James Scarola
Vice President
Harris Nuclear Plant

SERIAL: HNP-01-066
10CFR50.4

SHEARON HARRIS NUCLEAR POWER PLANT
DOCKET NO. 50-400/LICENSE NO. NPF-63
RESPONSE TO REQUEST FOR ADDITIONAL INFORMATION
STEAM GENERATOR REPLACEMENT AND POWER UPRATE

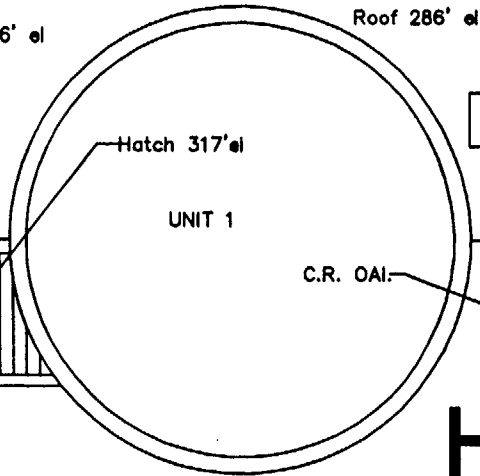
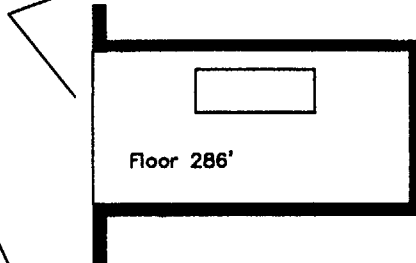
- In addition, list the accidents for which each set applies, as well as the postulated release location/receptor pairs. A figure would be helpful in understanding the physical relationship of the release locations and receptor pairs with respect to heights, distances, directions, and plant structures.

As stated above, only one set of X/Q values apply to all events. The simplified plant diagram provided by the staff in the February 22, 2001 meeting has been used to show the air intake and release locations. A copy of this diagram is attached to this RAI response (1 page).
